Access Assessment Report

255 Condamine Street, Manly Vale

Project: 255 Condamine Street, Manly Vale
Reference No: 113101-Access-r1
Date: 23 January 2021
Client: MY Manly Vale Ptd Ltd, atf Manly Vale Unit Trust
Client Contact: C/- Sean Gartner
Email: Sean@g-t.com.au
BCA Logic Project: Warwick Hunter
Direct: 84844077
Email: whunter@bcalogic.com.au

1. Lift Controls – Distance from Corners

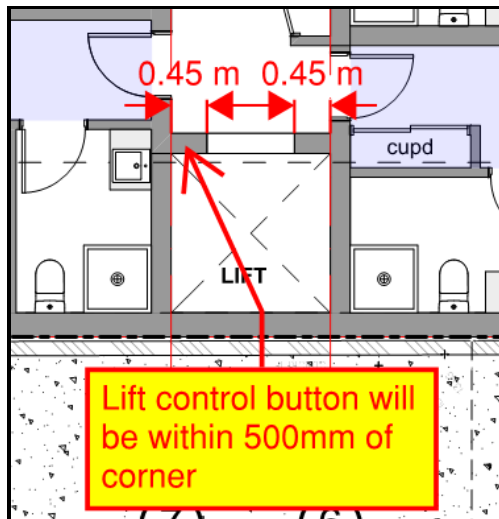
In accordance with the requirements of both AS1428.1-2009 and AS1735.12-199, each lift control button is required to be no closer than 500mm from any internal corner. The design of the lift to the rear building is such that the side walls to the lift shaft are 450mm and it would not be possible to position a lift control button 500mm from the corner.

Unless redesigned it will be necessary for a performance solution to be considered at Construction Certificate stage where it may be possible to justify a 300mm offset consistent with internal lift control buttons

2. Offset Stair Riser

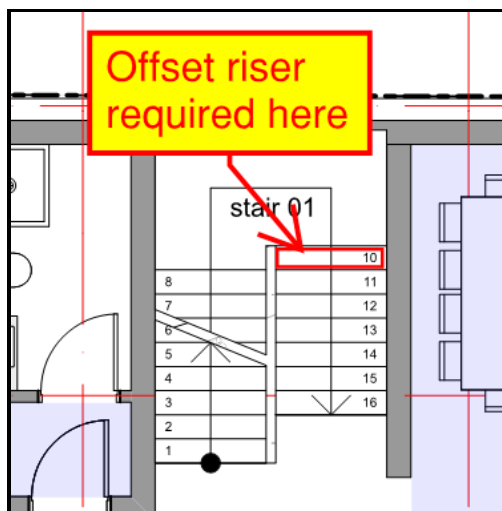
At all levels to both stairs 01 & 02, an offset riser is required to the descending stair flight at the mid landing in accordance with AS1428.1-2009.

Note: offset riser is needed to ensure consistent handrail heights around the landing as per AS1428
